# Fakir Knitwears Ltd.

19 December 2013

# Observations

## Columns strength

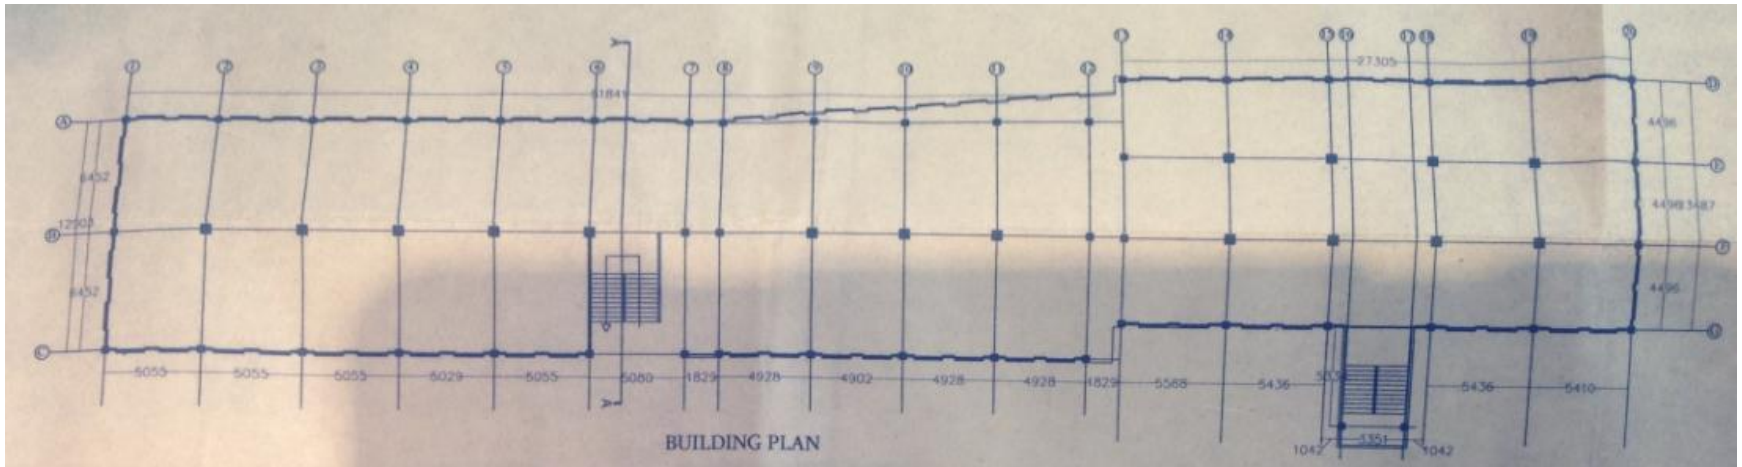
Cursory calculations indicate that internal and external columns working stress is at a high level in main building

A Detailed Engineering Assessment of the building is required (See attached Scope) . Engineer is to perform detailed calculations based on as constructed dimensions and concrete tests to prove column size and (if required) :

- Reduce loads by vacating floors and removing additional structures
- Reinforce columns

## Non engineered structure

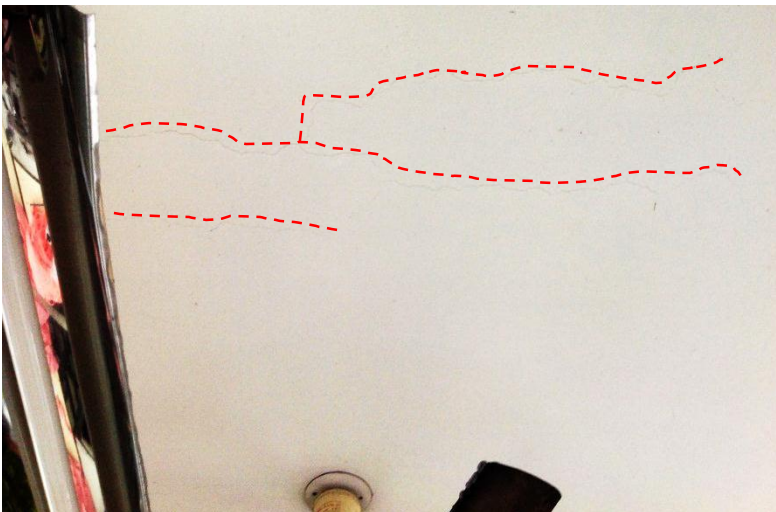
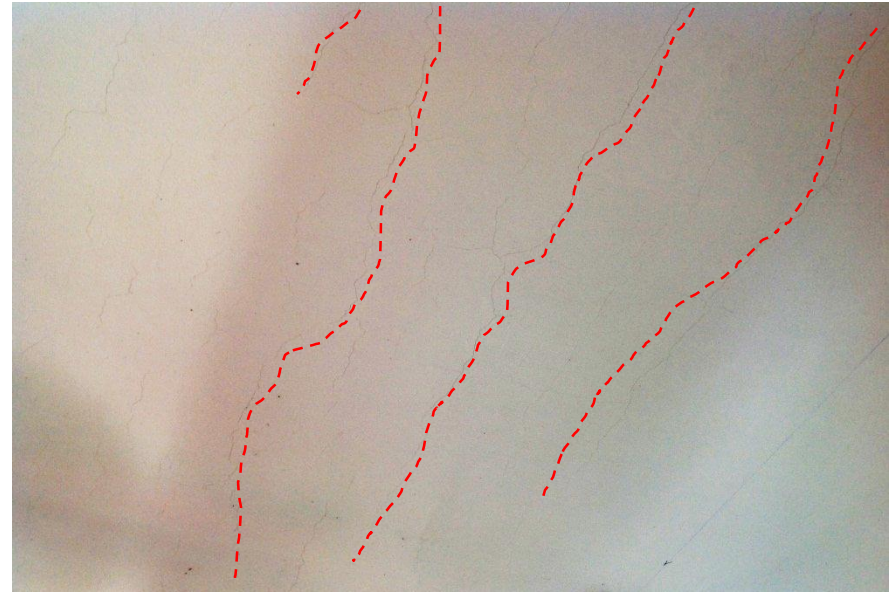
- One column missed in one of the frames without an obvious transfer element, this column is in all the frames except one.
- Connections do not appear to be designed.
- Connections do not appear to be constructed properly.

Item No.	Observation	Recommended Action Plan	Recommended Timeline
13	Non engineered steel structure in Main building's roof	Building Engineer to check the structure and connections and any required strengthening works to be implemented to ensure the proper functioning of the structure.	6-months
14	Cracking in slabs	Monitor cracks on slab. Conduct regular inspection of cracks. Investigate if cracks are only in the plastering/finishes.	6-weeks
15	Cracking in slabs	If cracks grow larger, removing all items above the slab and close working areas below the affected areas . Building Engineer to investigate, repair and strengthen the slab.	6-months
16	Slender columns in printing building's ground floor	Factory engineer to review design.	6-months
17	Slender columns in printing building's ground floor	If required, strengthen the columns.	6-months
18	Steel connections in Warehouse building. Connections not designed or executed improperly	Factory engineer to check connections.	6-weeks

## Cracking in slabs – Main & Printing

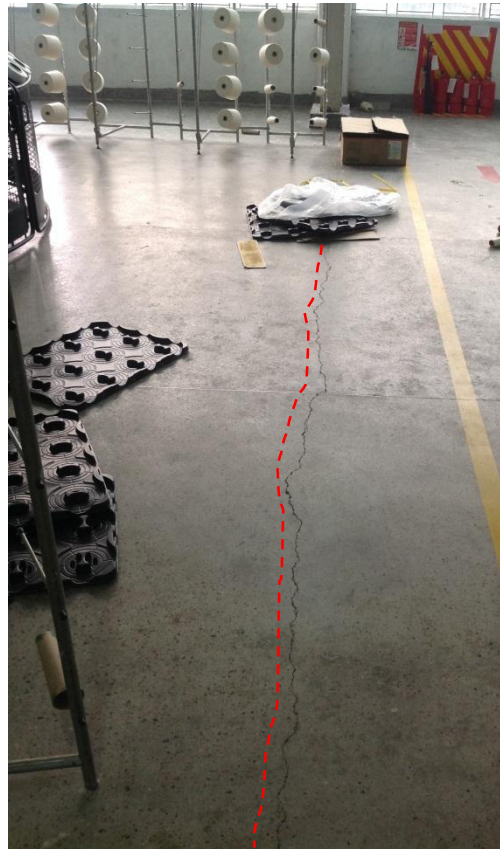
Cracks parallel to longest span detected in several floors. Cracks appeared concentrated at midspan area.

Building Engineer to check cracks are only into the plaster and to ensure crack do not continue into concrete slab.

## Cracking in slabs Knitting & Dyeing

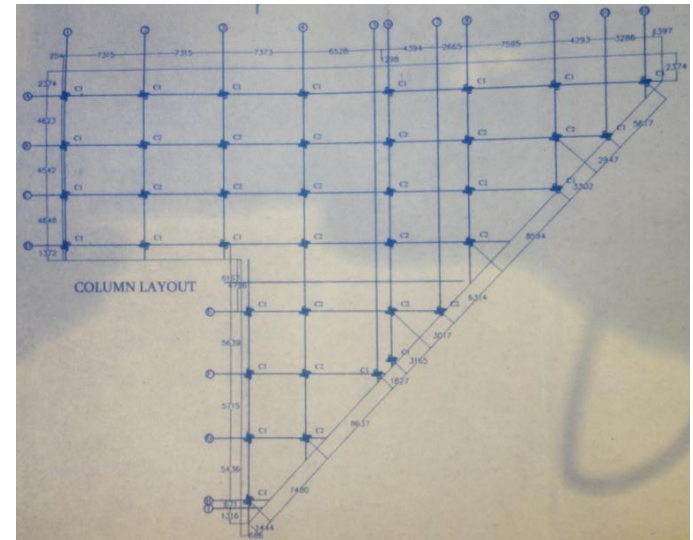
Cracks parallel to cantilever detected in slab between Knitting and Dyeing buildings. Cracks appeared concentrated at support area. Building Engineer to review support and check cracks are only in the plaster and to ensure cracks do not continue into concrete slab.

## Slender columns

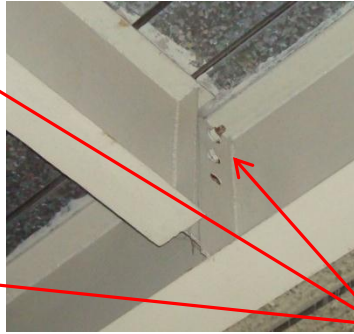
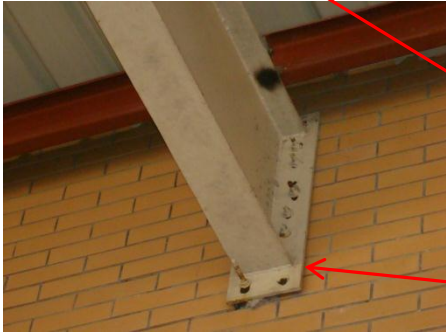
**Slender Columns**  
 Columns with dimensions 450x450 mm and 5900 mm high has been observed in the Printing building at ground floor. These columns do not match with the dimensions shown on drawings.

## Vertical and Horizontal stability

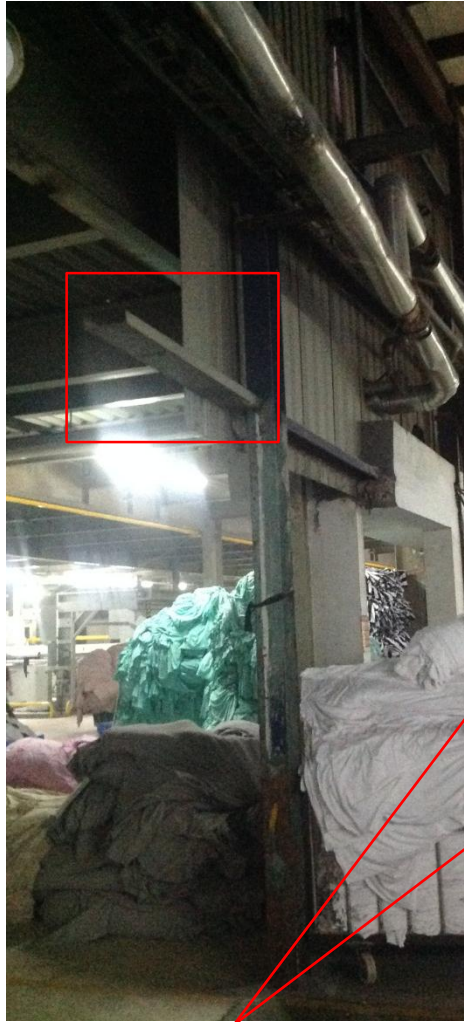
**Knitting and Warehouse buildings**  
Vertical stability system may be required  
Horizontal stability system on the roof plane needs to be tensioned
